DEALER SERVICE MEMO NO. 792

SUBJECT: New carburetors for the Super 2, VI-Super 2 and VI-Super 2SL, Lot #8307 and above.

DATE: 1-79

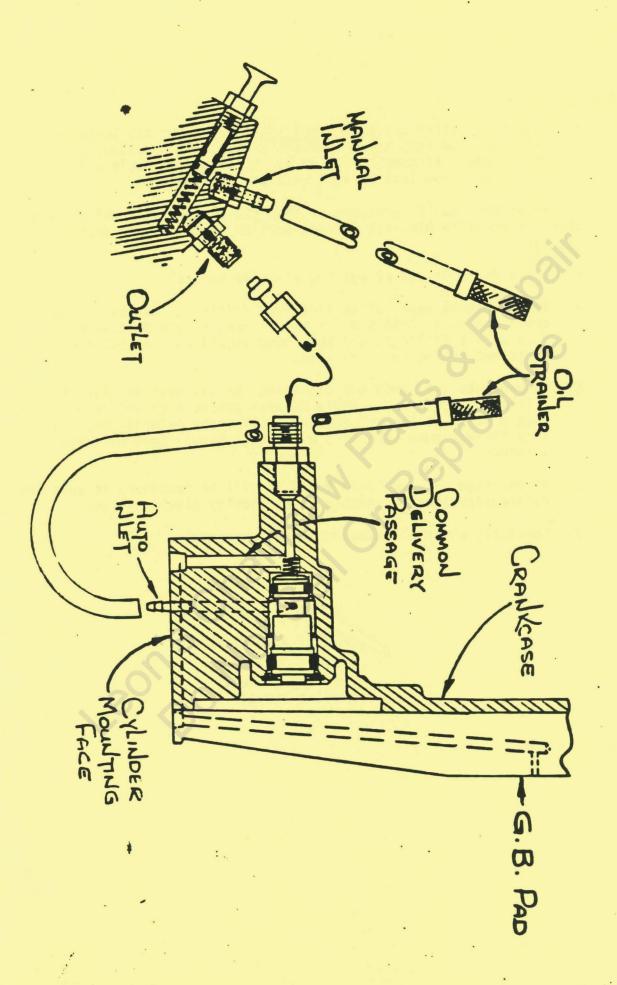
The automatic and manual oiler systems on these units are fully independent up to the point where they join in the common delivery passages in the crankcase (see sketch included). The independent design aids in the trouble-shooting steps for these oilers, allowing them to be tested one against the other.

- A. Check that ball check valve is sealing, and that pump body o-rings do not leak.
 - B. Insert a test plunger (modified per sketch), or similar tool, to lift the ball check valve to check for free flow through the delivery end of the pump body.

SUBJECT: IDENTIFICATION MODULE AND CORES

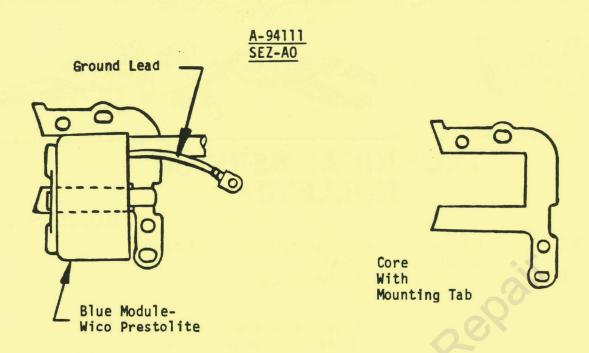
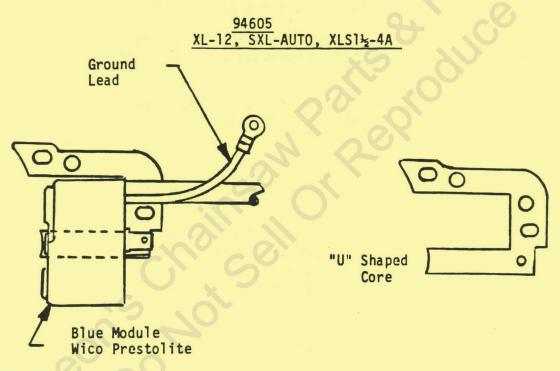
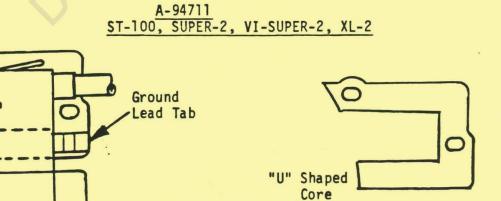
With the similarity in shapes and sizes of the module and cores for the above mentioned units, the illustrations shown on the back of this page should aid in identifying the differences in these parts.

Because there has been some confusion when identifying these parts, it is possible that some parts have been packaged under the wrong part numbers.

Please check your stock and verify that the proper parts are in their proper boxes, using the illustrations on the back.
